MIL-B-5087B(ASG)
Amendment 2
31 August 1970
Superseding
Amendment 1
6 February 1968

BONDING, ELECTRICAL, AND LIGHTNING PROTECTION, FOR AEROSPACE SYSTEMS

This amendment forms a part of Military Specification MIL-B-5087B(ASG), 15 October 1964, and has been approved by the Department of the Air Force and by the Naval Air Systems Command.

FIGURE 6. Fault current (Amperes)

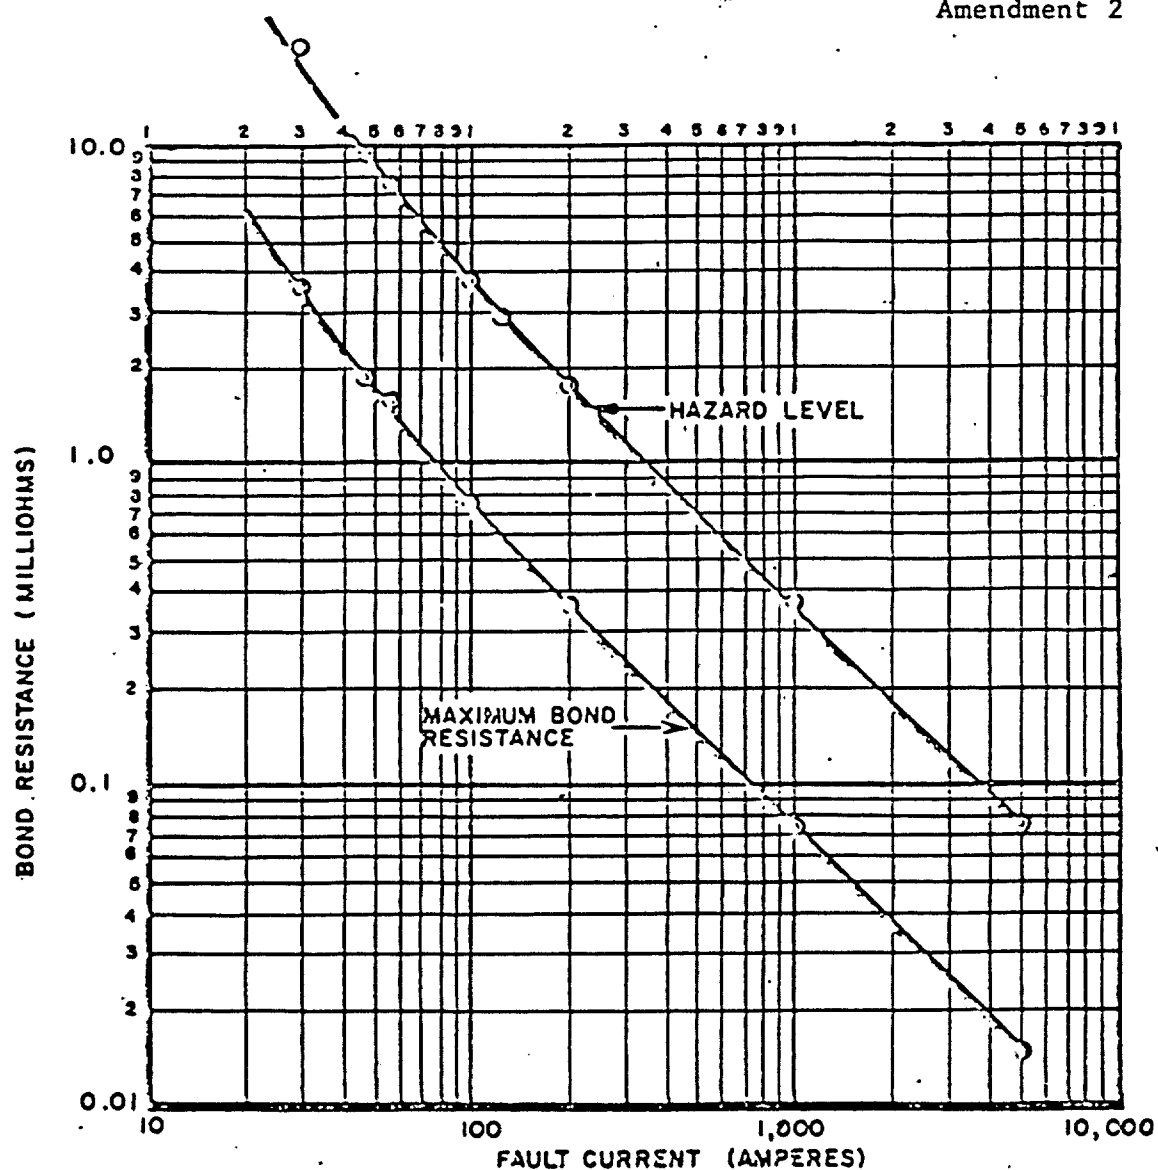
"3.3.2.4 Bonding in hazard areas. In areas prone to explosion or fire hazards; the resistance between the equipment case and structure shall not exceed the values shown on figure 6. The fault current shown is the maximum current that the electrical system is capable of delivering to the fault in the event that an internal power-to-ground fault takes place and high current passes through the equipment housing to structure. Since bonding in itself cannot eliminate all possible sources of ignition, the equipment shall be designed to minimize hot spots, sparking, and expulsion of molten metal when an internal power fault occurs.

Page 13, figure 6: Delete and substitute the attached figure 6. Figure 6 forms page 3 of this amendment.

AMPS	HAZARD RESISTANCE (MILLIOHMS)	MAX RESISTANCE (MILLIOHMS)
5000	0.074	0.0143
1000	0.37	0.074
200	1.35	0.37
120	2.33	—
100	3.7	0.74
58	7.7	1.54
49	9.3	1.35
30	18	3.6
